Subject: Catawba Nuclear Station
Docket Numbers 50-413 and -414
Proposed Change to MSSV Technical Specification
Setpoint Tolerances; Supplemental Information

Attachment 1

Attachment 2
Revised Technical Specification Table 3.7-1

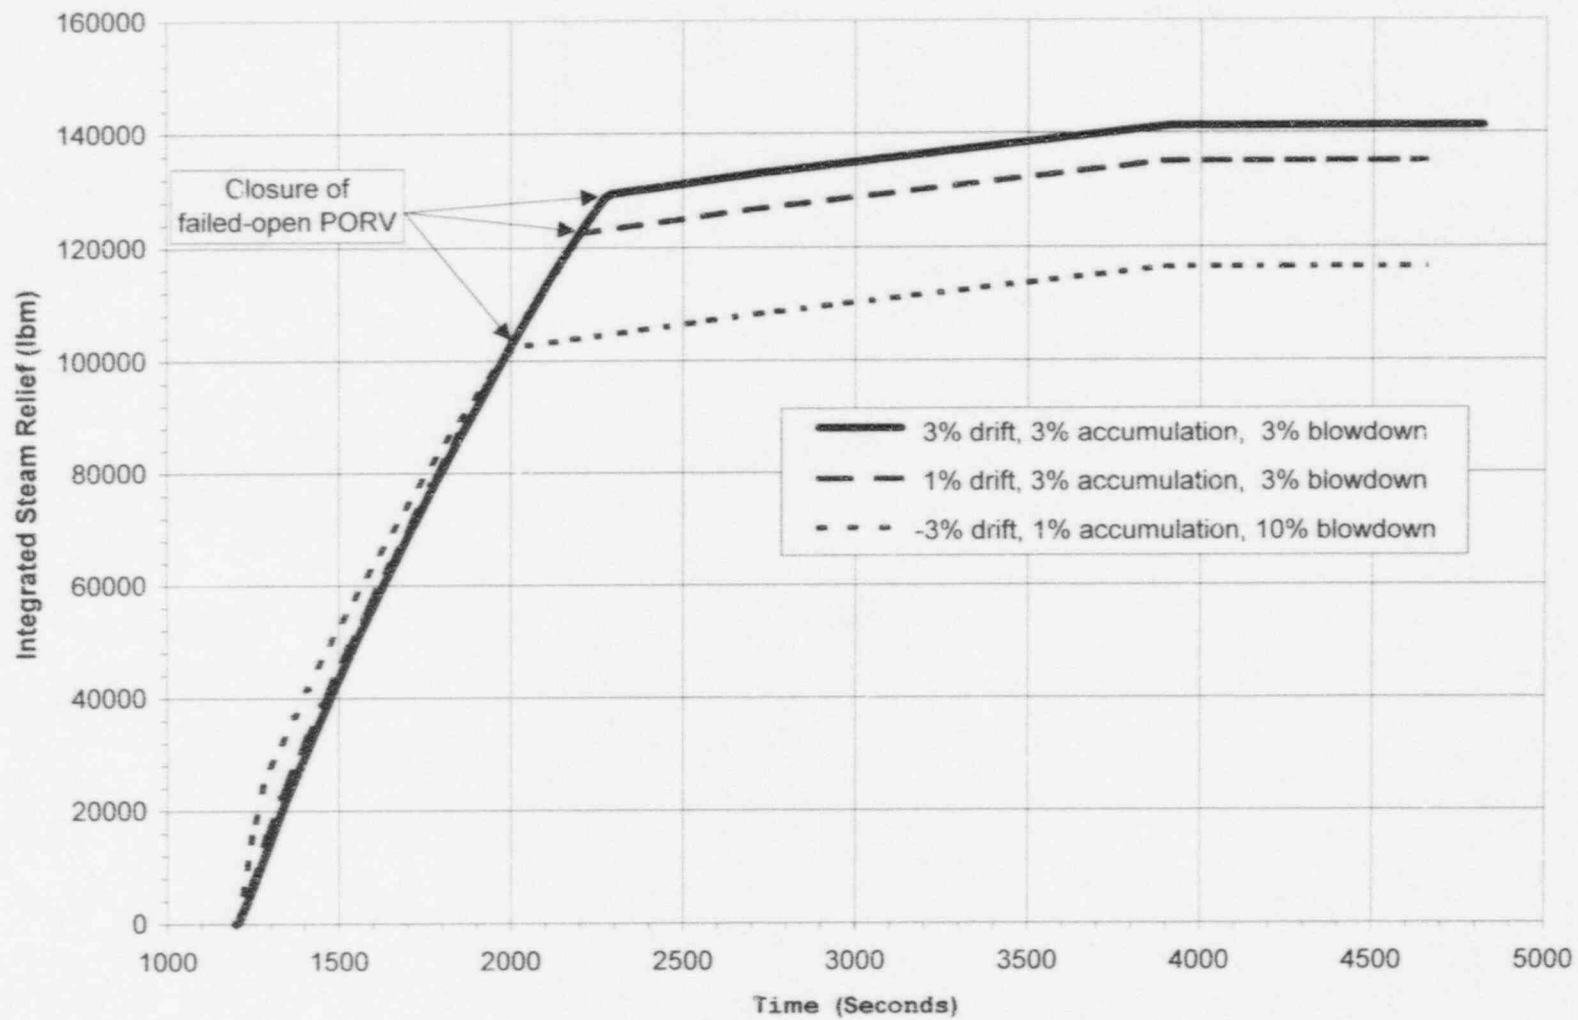
Provide clarification for the changes made to TS Table 3.7-1.

The change to Table 3.7-1 as submitted included a typographical error. The intent of the change was to remove both the footnote and the final line of the table which allowed operation in Mode 3 with 4 or 5 inoperable MSSVs. A replacement page for that Technical Specification change is included as Attachment 2.
